Access Compliance Report

Public Rights-of-Way

(Curb Ramps)

Intersection ID: 30686	Main Street: LANCASTER_HY	Cross Street: COPPER_MOUNTAIN_BV	Location: SE
ADA ID: A195DC5670A4	Ramp Type: Perp	Initial Pass/Fail: Fail	Overall Compliance: No
Severity Score: 8.75			
Codes/Mitigation Info/Possible Solution		Field Measurements/Component Compliance

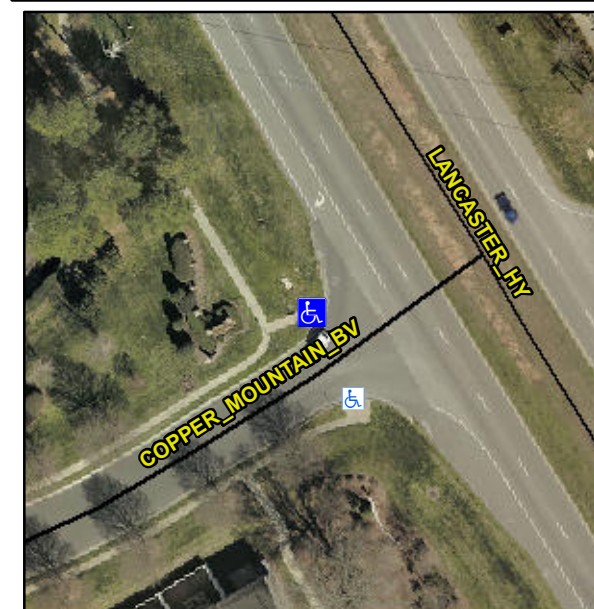
Not Found, R304.5.1

Compliance	Description	Data	Compliance	Description	Data
N/A	Ramp Length (in)	103.0	Yes	Ramp Slope (%)	7.7
No	Ramp Width (in)	47.0	Yes	Ramp XSlope (%)	0.8
N/A	Flare Type LT	N/A	N/A	Flare Type RT	N/A
N/A	Flare Slope LT (%)	N/A	N/A	Flare Slope RT (%)	N/A
N/A	Flare Traversable LT?	N/A	N/A	Flare Traversable RT?	N/A
N/A	Landing Length (in)	N/A	N/A	DWS Provided?	N/A
N/A	Landing Width (in)	N/A	N/A	DWS Contrast?	N/A
N/A	Landing Slope (%)	N/A	N/A	DWS Length (in)	N/A
N/A	Landing X Slope (%)	N/A	N/A	DWS Full Width?	N/A
N/A	Landing Curb? (Y/N)	N/A	N/A	DWS Offset (in)	N/A
N/A	Shared Landing?	N/A			
N/A	Gutter Ponding?	N/A	N/A	Gutter Slope (%)	N/A
N/A	Gutter Lip Ht (in)	N/A	N/A	Gutter X Slope (%)	N/A
N/A	Painted X Walk1?	No	N/A	Painted X Walk2?	N/A
	X Walk 1 Direction	To SE		X Walk 2 Direction	N/A
N/A	X Walk 1 Width (in)	N/A	N/A	X Walk 2 Width (in)	N/A
	X Walk 1 Slope (%)	2.5		X Walk 2 Slope (%)	N/A
	X Walk 1 X Slope (%)	0.9		X Walk 2 X Slope (%)	N/A

Remove & Replace Entire Ramp.
